ORDINANCE NO. \_\_\_\_\_

AN ORDINANCE to amend and reordain the Master Plan of the City of Alexandria, Virginia, by adopting and incorporating therein the amendment heretofore approved by city council to the Potomac West Small Area Plan chapter of such master plan through the Oakville Triangle & Route 1 West Corridor and Vision Plan Overlay as Master Plan Amendment No. 2020-00003 and no other amendments, and to repeal all provisions of the said master plan as may be inconsistent with such amendment.

## Oakville Plan updates as amended:

## Figures 3 & 18: Illustrative Plan

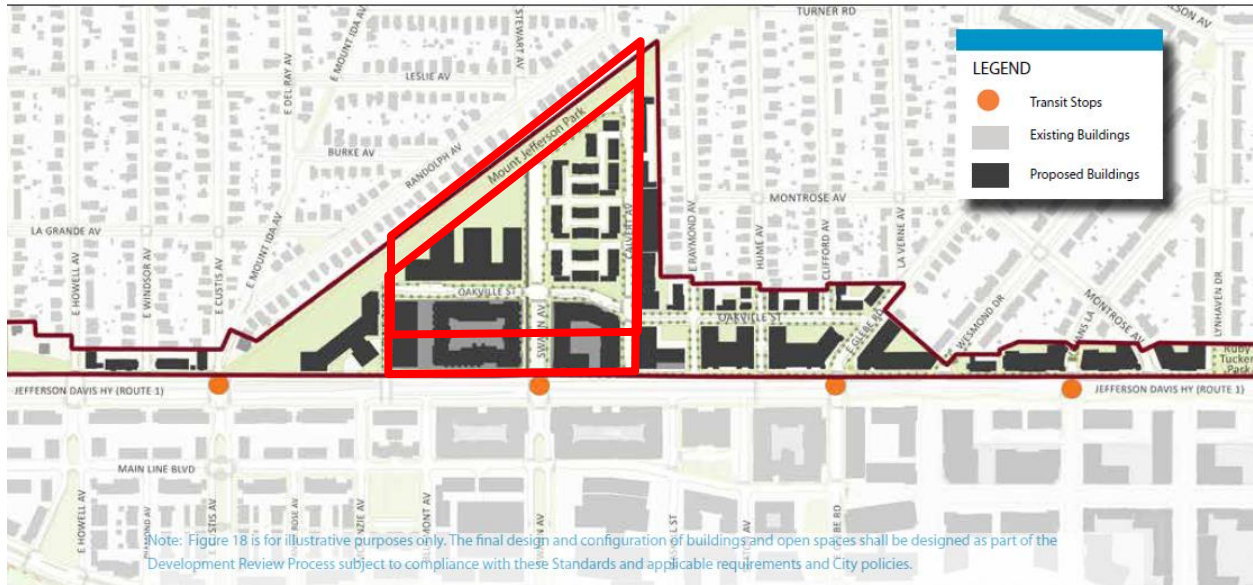
- Figure 3 & 18: Illustrative Plan
- Figure 7: Oakville Triangle District
- Figure 19: Framework Streets
- Figure 25: Land Uses
- Figure 27: Maximum Building Heights
- Figure 28: Minimum Building Heights
- Figure 29: Open Spaces (Public, Ground level and Roof-top)
- Figure 30: Open Spaces adjacent to Mount Jefferson Park
- Figure 41: Ground Floor Uses: ~~Primary, Secondary~~ Retail, and Maker Spaces
- Figure 47: New and Reconfigured Streets
- Street Cross-Sections: Pages 117 - 125
- P.24: Transportation Improvements Table
- Chart 1: Public Benefits Phasing
- Chart 2: Development Summary Table

Figure 7: Oakville Triangle District

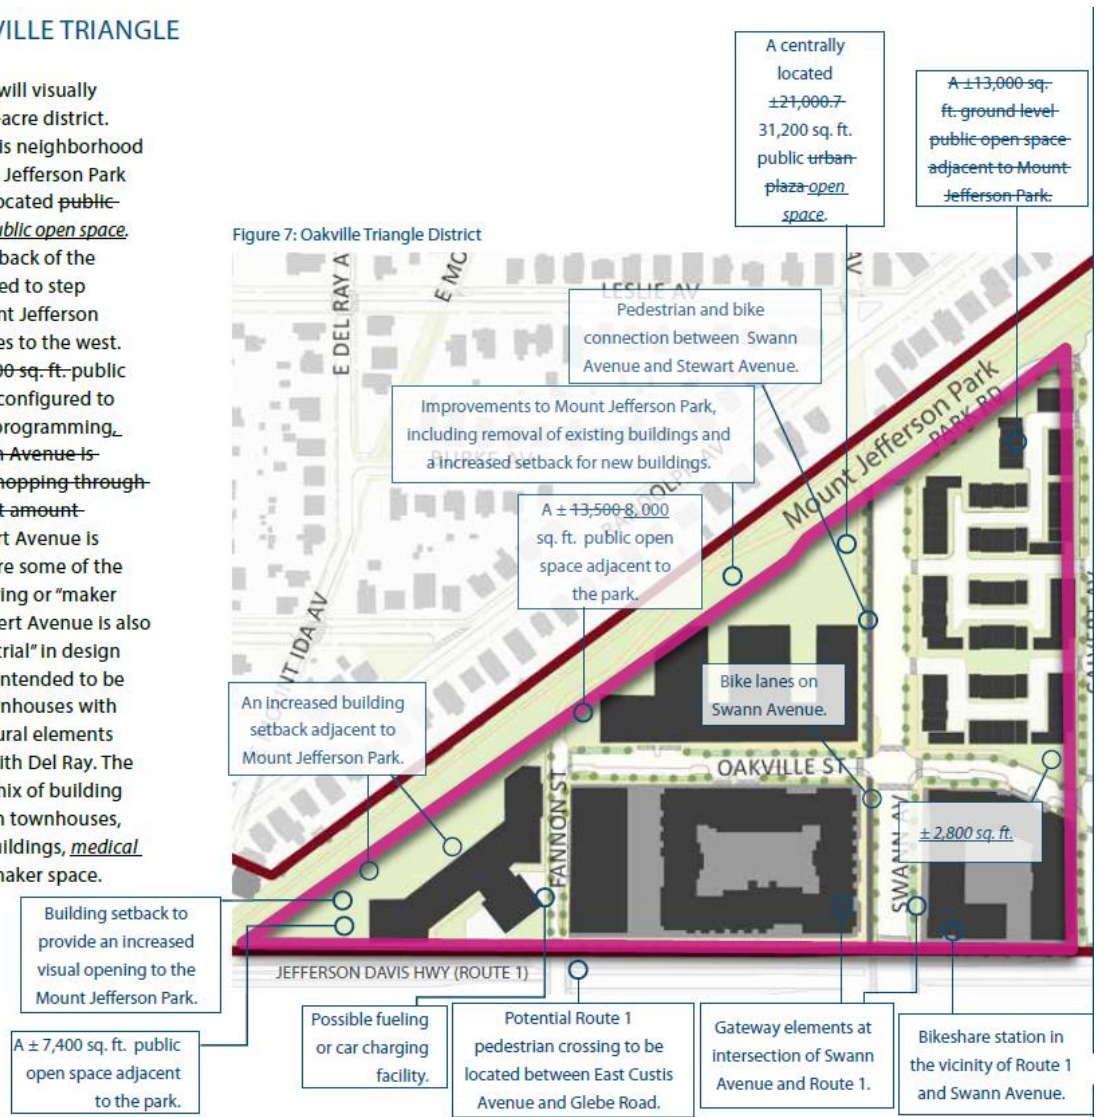
Establishing the street grid will visually unify this approximately 15-acre district. The defining elements of this neighborhood will be the adjoining Mount Jefferson Park frontage and the centrally located public urban plaza ± 31,200 sq. ft. public open space. The building height and setback of the buildings have been designed to step down to the adjoining Mount Jefferson Park and single-family homes to the west. The centrally located ±21,000 sq. ft. public open space will need to be configured to accommodate events, and programming, and social gatherings. Swann Avenue is intended to provide retail shopping through the provision of a significant amount of ground floor retail. Calvert Avenue is intended to be an area where some of the existing neighborhood-serving or "maker uses" could be located. Calvert Avenue is also intended to be more "Industrial" in design and character. Park Road is intended to be smaller scale 30'-45' tall townhouses with front porches and architectural elements and materials compatible with Del Ray. The district is intended to be a mix of building types and uses ranging from townhouses, multi-family, office, hotel buildings, medical care facility, and retail and maker space.

Figure 30: Open Spaces adjacent to Mount Jefferson Park

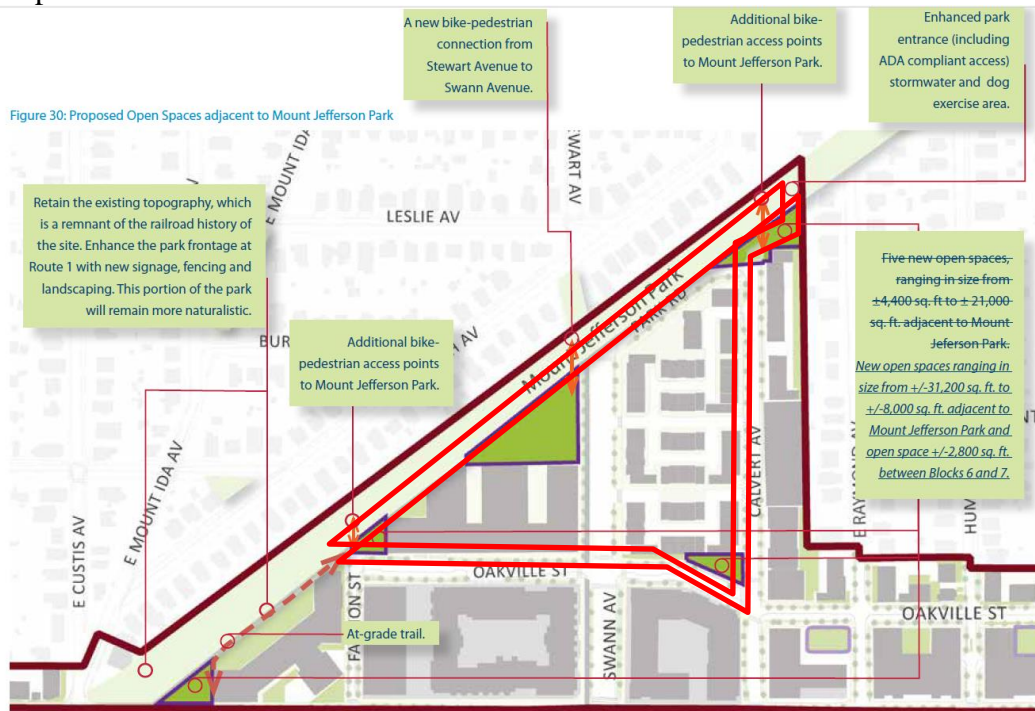
- Amend Standard 4.18, as follows: ~~The five~~ new open spaces adjacent to Mount Jefferson Park shall be constructed as generally depicted in Figure 30, as part of the redevelopment

- Amend Standard 4.18, as follows: ~~The five~~ new open spaces adjacent to Mount Jefferson Park shall be constructed as generally depicted in Figure 30, as part of the redevelopment adjacent to the Mount Jefferson Park. The at grade trail (lower trail) extension on the northern portion shall be constructed by the adjoining property owner.
- Amend Standard 4.19, as follows: The central open space within Oakville Triangle shall ~~be hardscape with~~ have appropriate plantings, shade options, and lighting and shall contain high-quality materials and finishes, as well as the inclusion of public art or other focal features. The open space/~~plaza~~ shall be accessible to the public through the provision of a public access easement.

p.121 (Adopted 2020 Amendment)

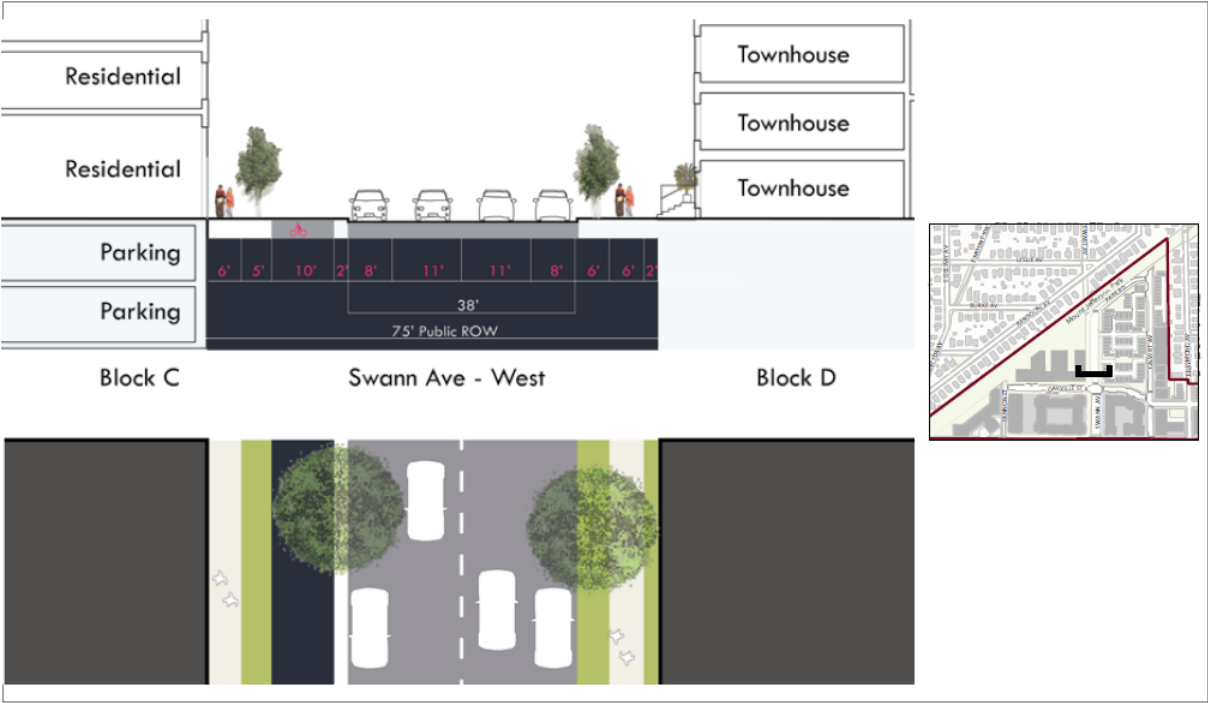
- Amend the Typology header text, as follows: TYPOLOGY: ~~SHARED STREET~~ NEIGHBORHOOD RESIDENTIAL

Chart 1: Public Benefits Phasing (Adopted 2020 Amendment)

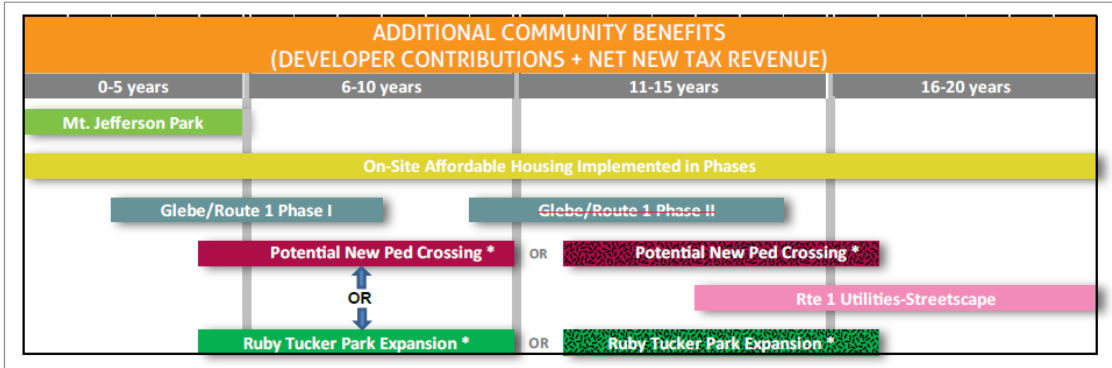
- Amend the first column header, as follows: PHASE 1\* - OPERATIONAL PRIOR TO 800,000 SQ. FT. (NET WITHOUT PARKING)
- Amend the first note in the first column, as follows: 1 - Signal modifications at Route 1 and E. Reed Ave\* (with North Potomac Yard first building)
- Add a note to the first column, as follows: 8 - New signalized intersection improvements and pedestrian crossings at Route 1/Fannon Street
- Amend the fifth note in the second column, as follows: 8 - Pedestrian crossing across Route 1 ~~(at Fannon St. or Raymond Ave)~~
- Delete the first note in the third column, as follows: 9 - ~~Improvements at Route 1/ E. Glebe (Phase 2)~~
